Notice of Allowability	Application No.	Applicant(s)	
	10/629,864	UMEYAMA ET AL.	
	Examiner	Art Unit	
	LOHA BEN	2873

EXAMINER'S AMENDMENT

FIG. 67 (PRIOR ART)

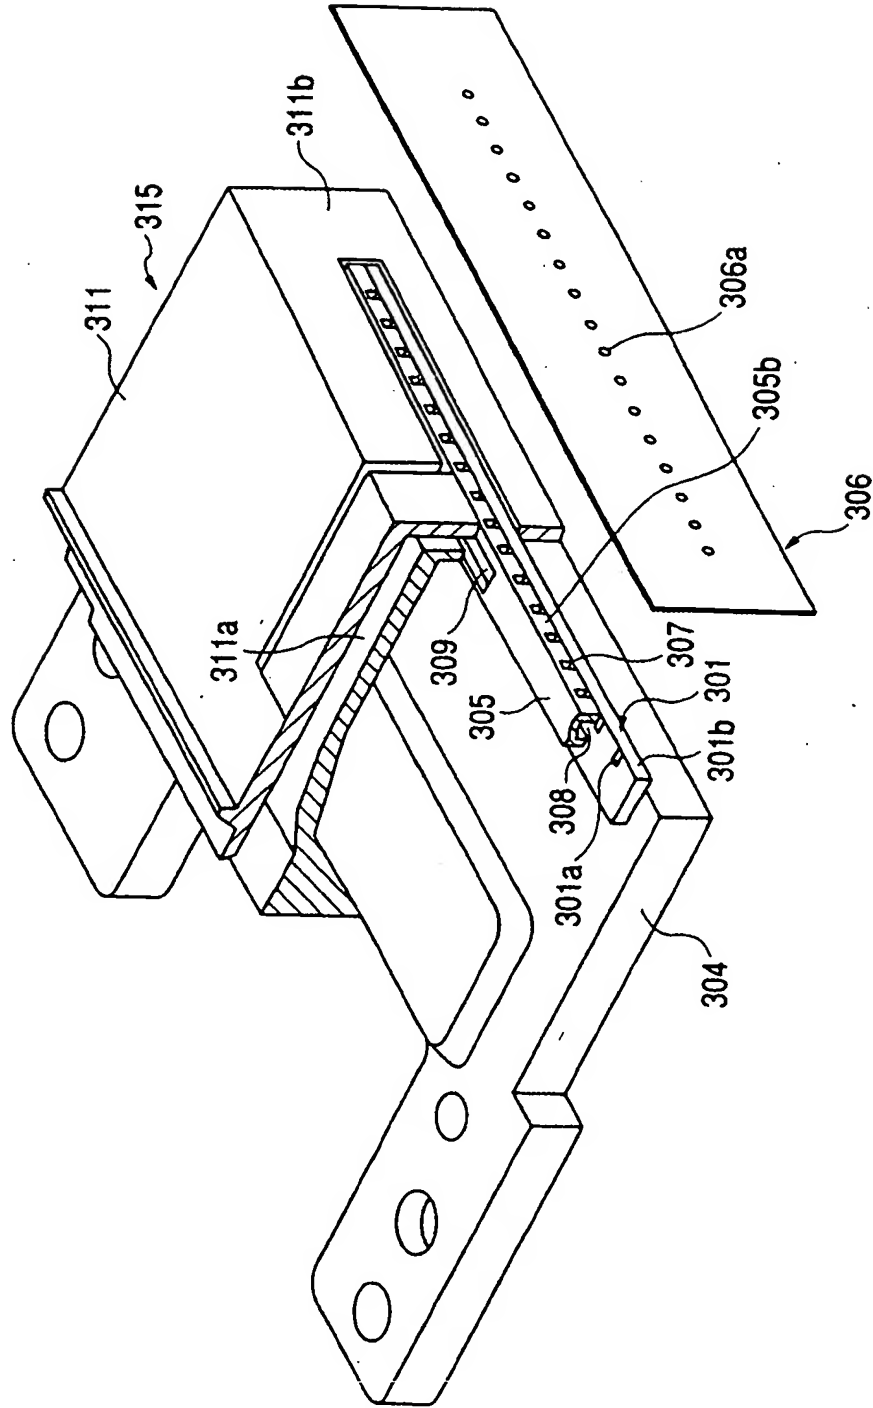
Figs. 67-70 have been labeled each – PRIOR ART --.
